**Detroit
Edison**

References: NRC Review Comments on Fermi 2 Emergency
Plan, March 1981, dated July 6, 1981

Subject: Enrico Fermi Atomic Power Plant, Unit 2
NRC Docket No. 50-341
Radiological Emergency Response Plan

NRC REVIEW COMMENTS
FERMI 2 RADIOLOGICAL EMERGENCY RESPONSE PLAN

FIGURE 4-1

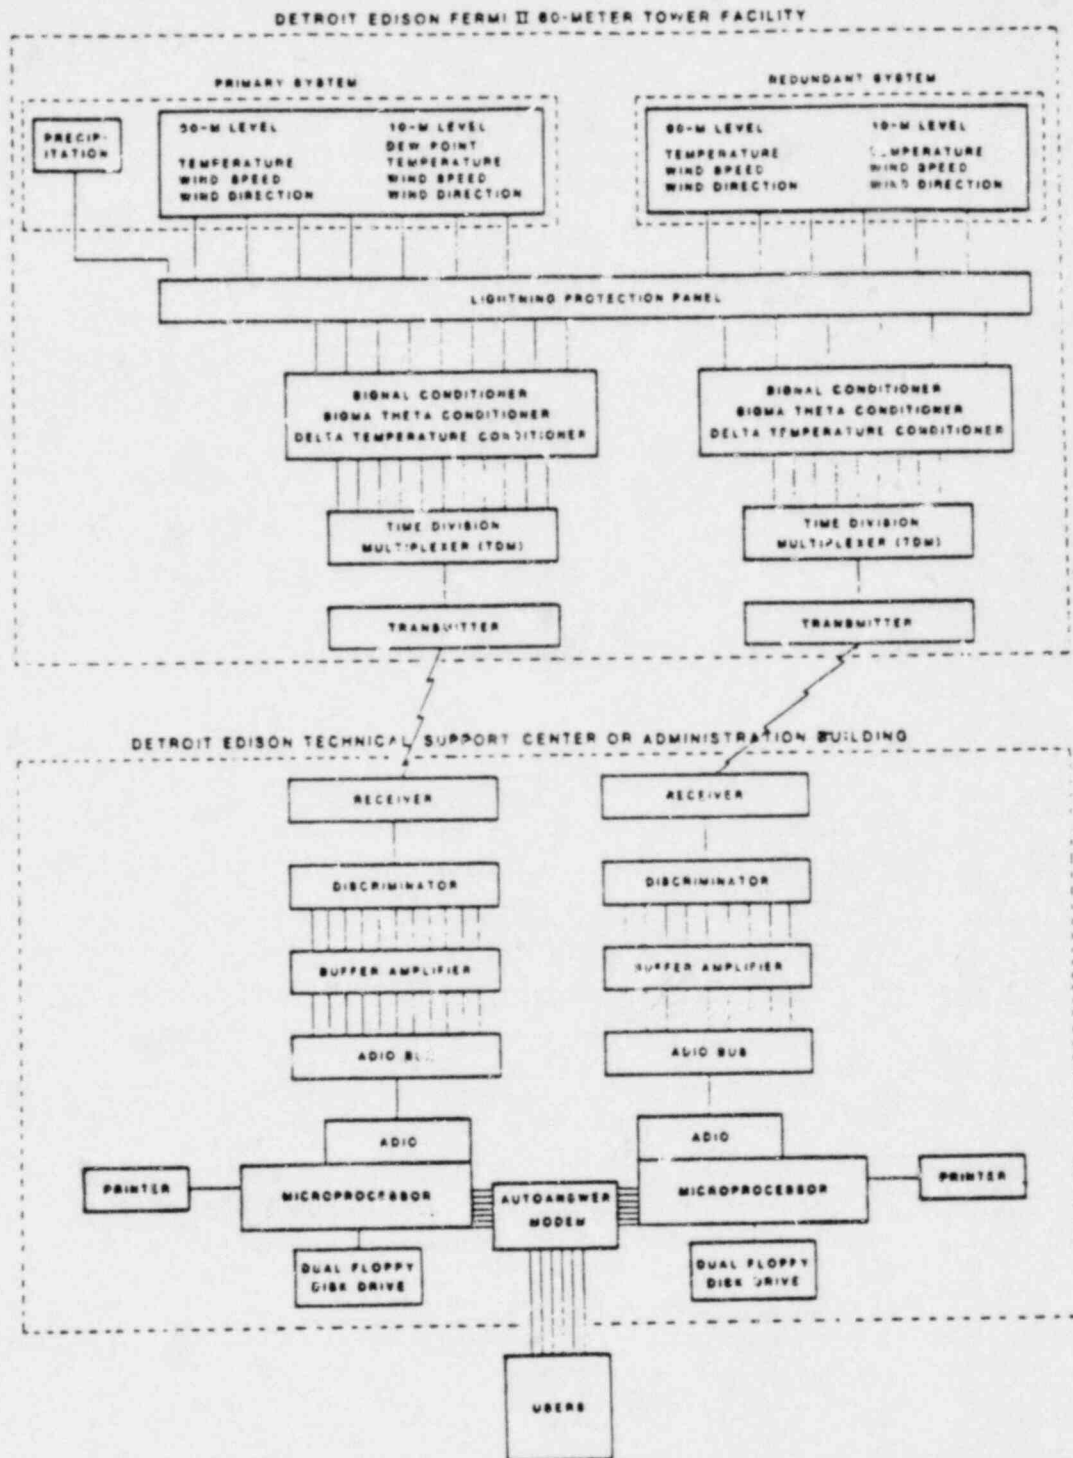
- H.5. Provide a description of the meteorological instrumentation and procedures as identified & in Appendix 2 of NUREG-0654, Rev. 1 and the provisions to obtain representative real-time meteorological information from other

Meteorological instrumentation is described in Appendix 1 to these responses.

A backup system will consist of wind speed, wind direction, and sigma theta mounted at the 10-meter level of the 150-meter tower presently onsite. Tables H-1, H-2, and H-3 indicate the parameters measured, the sensor descriptions, and the signal conditioners, respectively. Figure H-1 shows a block diagram of the modified system. This is subject to change as design progresses.
